**CONTAMINATION ASSESSMENT REPORT ADDENDUM  
S-3 CRASH SITE**

**NAVAL AIR STATION CECIL FIELD  
JACKSONVILLE, FLORIDA**

SUBJECT: Contamination Assessment Report, dated February 1994  
S-3 Crash Site, Naval Air Station Cecil Field, Florida

**FIGURE 2-1  
SOIL BORING AND TEMPORARY  
MONITORING WELL LOCATIONS**

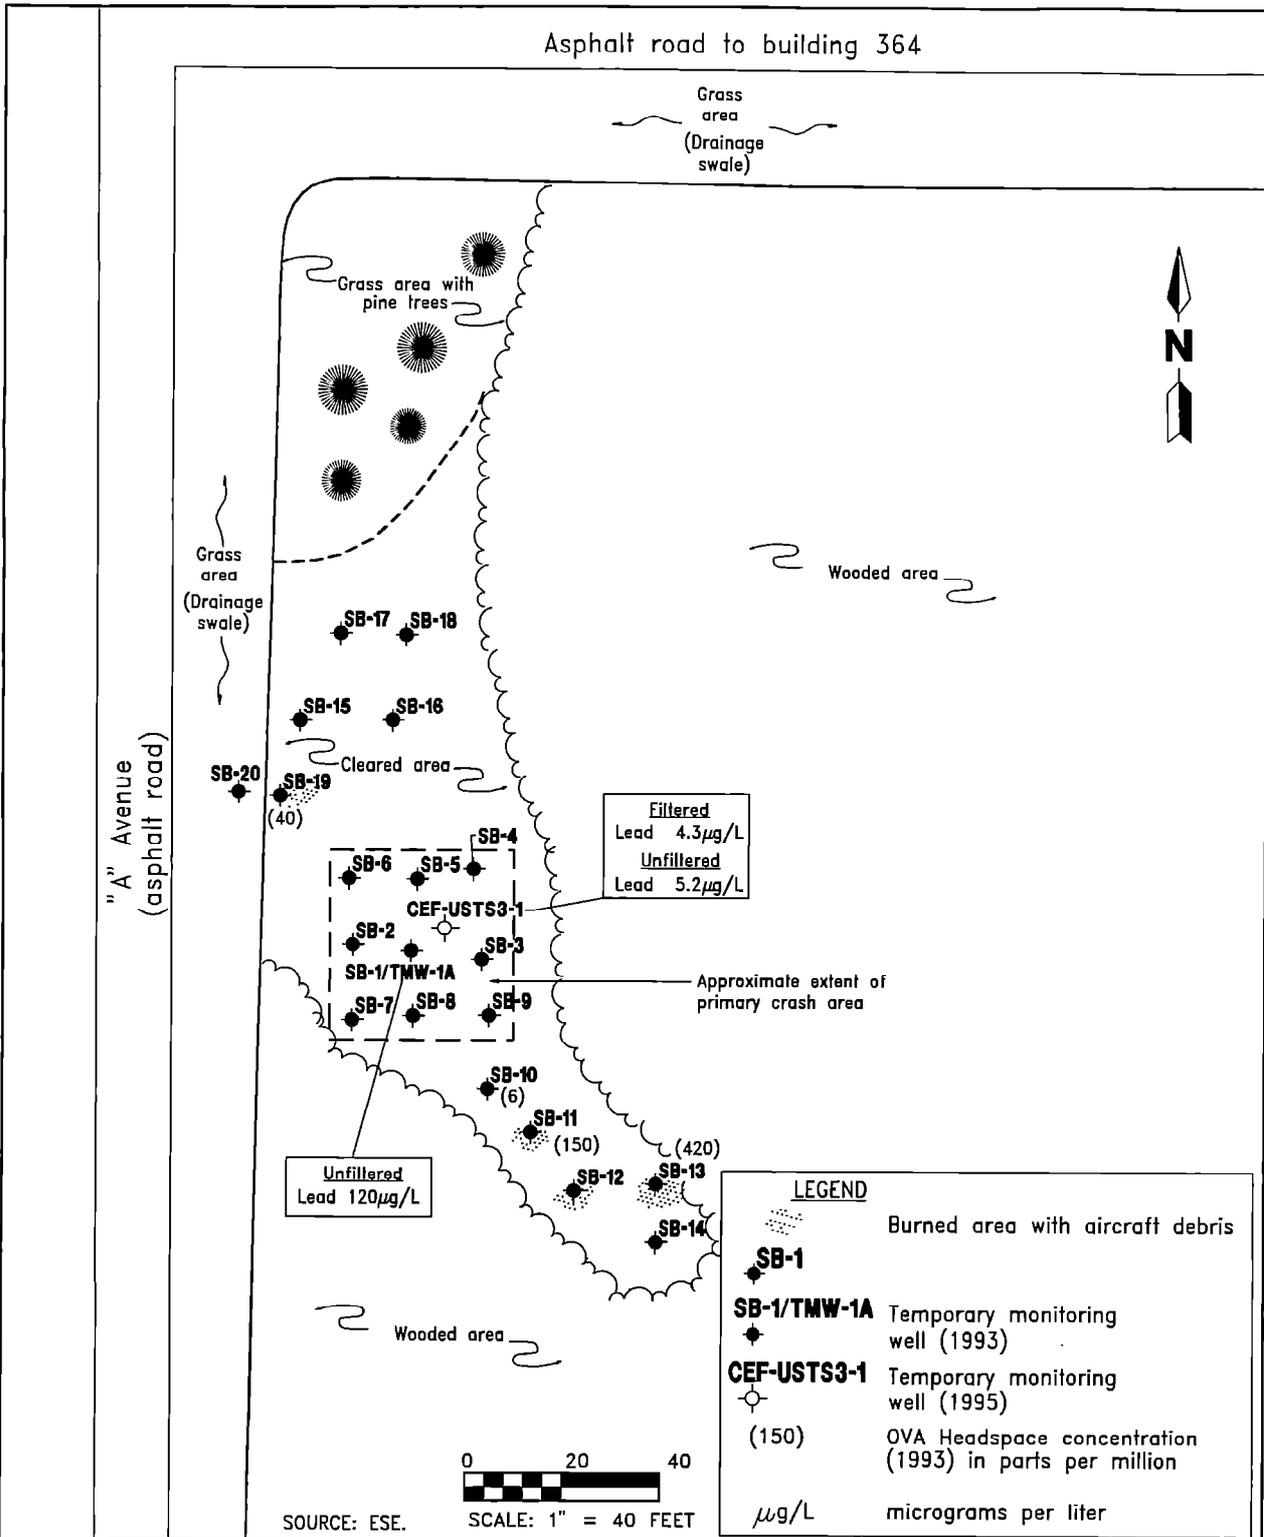
I have completed the review of the Contamination Assessment Report (CAR) and No Further Action (NFA) proposal dated February 1994 (received March 21, 1994), submitted for the above-referenced facility. The NFA cannot be approved at this time because of the presence of excessive lead in temporary monitoring well TMW-1A. The amount of lead, 120 parts per billion exceeds the allowable limit for a NFA. I agree with the proposed excavation and proper disposal of excessively contaminated soils as required by Chapter 17-770, Florida Administrative Code (F.A.C.), and that confirmatory headspace samples be taken following excavation. Therefore, in order to fully meet the requirements of Rule 17-770.600(7), F.A.C., the following supplemental data is requested:

1. A shallow groundwater monitoring well should be installed in the approximate location of TMW-1A. This well should be designed to bracket the water table and be sampled and analyzed by EPA Methods 239.2. Care should be taken in trying to obtain a turbid-free sample. In order to achieve a non-turbid sample, a quiescent sampling technique is suggested.
2. The results of the supplemental assessment should be submitted to the Department within 90 days. An expedited assessment is desirable, so that this site can become a Category 4 Site (Dark Green) under the BRAC Cleanup Plan (BCP) and the Environmental Baseline Survey (EBS) and be considered suitable for transfer.

Monitoring Well Installation and Sampling. One temporary monitoring well (CEF-USTS3-1) was installed by ABB Environmental Services, Inc. (ABB-ES) on March 2, 1995, approximately 8 feet northeast of the previous location of temporary monitoring well TMW-1A (Figure 2-1). The well was installed using 6.25-inch inside diameter hollow stem augers. The well was constructed of 2-inch inside diameter, flush-threaded, schedule 40, polyvinyl chloride (PVC) screen and riser. The screen was composed of 0.010 inch slotted PVC and was installed between 1.5 and 11.5 feet below land surface. A 20/30 grade silica sand filter pack and a bentonite seal were installed around the well. The well was not grouted to the surface so it could be easily abandoned after sampling. The lithologic log and monitoring well construction diagram for well CEF-USTS3-1 are presented in Appendix B. The newly installed well was purged under low-flow conditions (to minimize turbidity) and sampled for lead on April 30, 1995. The well was purged with a peristaltic pump for 4 hours and the lowest measured turbidity was 80 nephelometric turbidity units (NTUs). Since the turbidity could not be reduced after extensive purging, both filtered and unfiltered groundwater samples were collected. Monitoring well development and groundwater sampling logs can be found in Appendix C.

The results of the groundwater analysis indicated a lead concentration of 5.2 ppb in the unfiltered sample and a lead concentration of 4.3 ppb in the filtered sample. Both lead concentrations are below the Florida groundwater guidance criteria of 50 ppb. Laboratory analytical data are included in Appendix D.
